# UNITED STATES PATENT AND TRADEMARK OFFICE

APPLICATION NO.	FILING DATE	FIRST NAMED INVENTOR	ATTORNEY DOCKET NO.	CONFIRMATION NO.
10/619,459	07/16/2003	Wataru Ishimaru	088473-0136	7706

## Office Action Summary

### **DETAILED ACTION**

**FIG.10**

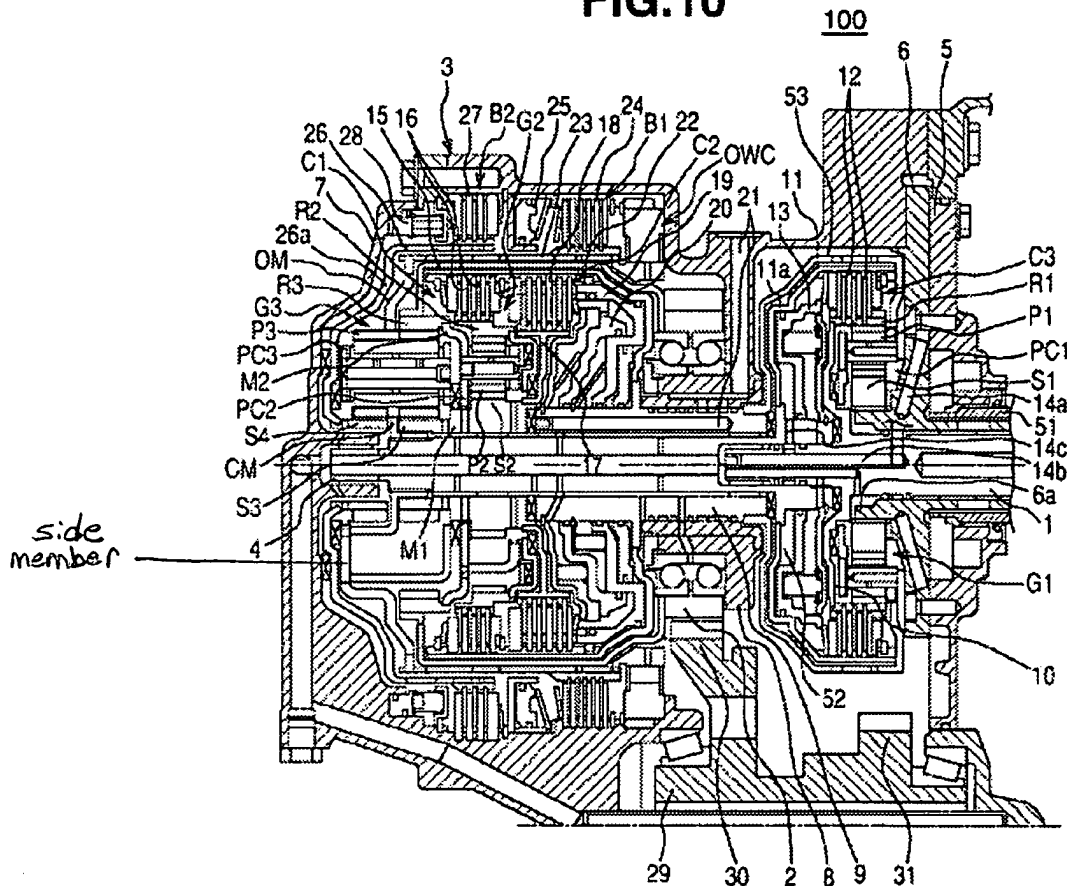
Claims 1-18 are rejected under 35 U.S.C. 102(e) as being anticipated by Tsuga ('551). As to claims 1 and 18, Tsuga discloses a gear change speed unit for an automatic transmission having, an input part (1), an output part (2), three planetary gear sets (G1, G2, G3), clutches (C1-C3) and brakes (B1, B2) providing at least six forward speed and one reverse speed (Figure 2), the first gear set reducing input rotation at all times and having a first sun gear (S1), a first pinion (P1), a first ring gear (R1) and a first carrier (PC1), the second gear set having a second sun gear (S2), a second pinion (P2), a second ring gear (R2), the third gear set having a third and fourth sun gear (S3, S4), a third pinion (P3) meshed with both sun gears, a third ring gear (R3), a third carrier (PC3), a center member (CM) coupled to a side member (Figure 10) supporting the third pinion with the third sun gear being close to the input part and the fourth sun gear being distant from the input part, the second and third gear sets constituting a change

As to claim 2, Tsuga discloses the first and second clutches (C1, C2) providing output from the first gear set arranged closer to the second gear set than the third gear set.

As to claim 3, Tsuga discloses the first and second clutches having pistons (Figure 10) arranged on the side of the second gear set distant from the third gear set.

As to claim 4, Tsuga discloses the third clutch (C3) providing rotation of the input part arranged at an outer periphery of the first gear set.

As to claim 5, Tsuga discloses the third clutch having a piston (Figure 10) arranged on a side of the first gear set closer to the second gear set.

As to claim 9, Tsuga discloses the first and second brakes (Figure 10) arranged closer to the second gear set than the third gear set.

As to claim 10, Tsuga discloses both brakes arranged at an outer periphery of the first and second clutches (Figure 10).
